# Service NOTIFICATION

## Recovery System Shoot out Opening Check

**SN-LTUL-CT\_\_-06;  
SN-LTUL-CT2k-07**

#### Flight Design CT & CT2K

### Technische Mitteilung Nr. 2:

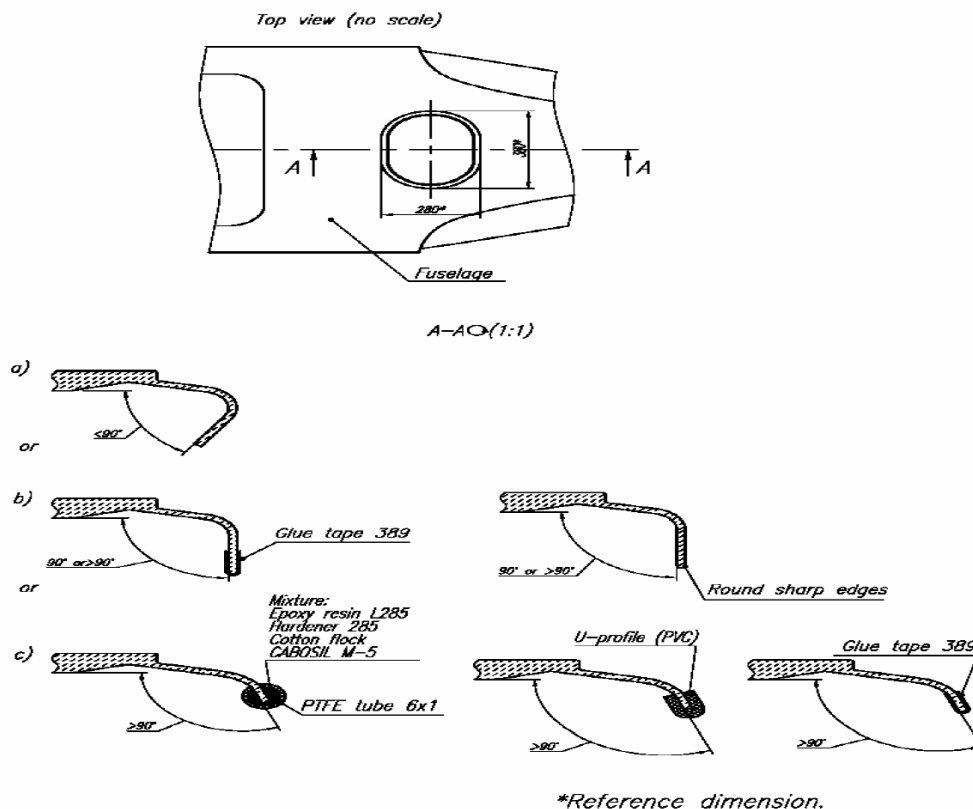
- Bei allen CT und CT2K ist nachzuprüfen ob der Wulst der Rettungsgeräteausschussöffnung den Anforderungen der beiliegenden Skizze a) entspricht (Winkel kleiner  $90^\circ$ ). Sollte dies nicht der Fall sein, so ist entsprechen:
  - Winkel gleich  $90^\circ$ , Skizze b)
  - Winkel größer  $90^\circ$ , Skizze c) zu verfahren.
 Hierzu ist entweder ein Gewebeklebeband, oder eine geschlitzter PTFE oder Gummischlauch oder ein PVC U-Profil als Kantenschutz zu verwenden.
- Gleichzeitig ist zu überprüfen, ob die Aufkleber des Rettungsgerätehersteller an der Ausschussöffnung und am Rettungsgerätegriff angebracht sind.
